Access Compliance Report

Public Rights-of-Way

(Curb Ramps)

Intersection ID: 51073	Main Street: RISBURG_LN	Cross Street: KEMPSFORD_DR	Location: E
ADA ID: CA82FFD2F83A	Ramp Type: Perp	Initial Pass/Fail: Fail	Overall Compliance: No
Codes/Mitigation Info/Possible Solution		Field Measurements/Component Compliance	
Severity Score: 13.75

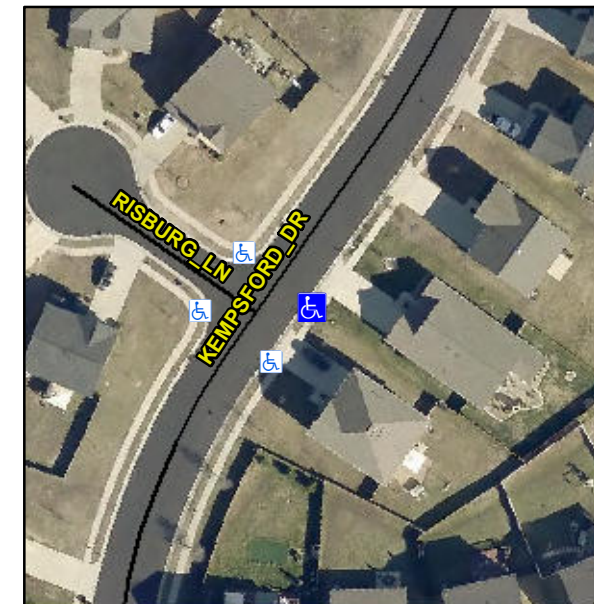
Not Found, R304.2.2, R304.5.3

Compliance	Description	Data	Compliance	Description	Data
N/A	Ramp Length (in)	48.0	No	Ramp Slope (%)	8.5
Yes	Ramp Width (in)	48.0	No	Ramp XSlope (%)	2.1
N/A	Flare Type LT	N/A	N/A	Flare Type RT	N/A
N/A	Flare Slope LT (%)	N/A	N/A	Flare Slope RT (%)	N/A
N/A	Flare Traversable LT?	N/A	N/A	Flare Traversable RT?	N/A
N/A	Landing Length (in)	N/A	N/A	DWS Provided?	N/A
N/A	Landing Width (in)	N/A	N/A	DWS Contrast?	N/A
N/A	Landing Slope (%)	N/A	N/A	DWS Length (in)	N/A
N/A	Landing X Slope (%)	N/A	N/A	DWS Full Width?	N/A
N/A	Landing Curb? (Y/N)	N/A	N/A	DWS Offset (in)	N/A
N/A	Shared Landing?	N/A			
N/A	Gutter Ponding?	N/A	N/A	Gutter Slope (%)	N/A
N/A	Gutter Lip Ht (in)	0.5	N/A	Gutter X Slope (%)	N/A
N/A	Painted X Walk1?	No	N/A	Painted X Walk2?	N/A
	X Walk 1 Direction	To NW		X Walk 2 Direction	N/A
N/A	X Walk 1 Width (in)	N/A	N/A	X Walk 2 Width (in)	N/A
	X Walk 1 Slope (%)	4.2		X Walk 2 Slope (%)	N/A
	X Walk 1 X Slope (%)	1.9		X Walk 2 X Slope (%)	N/A

Remove & Replace Entire Ramp.
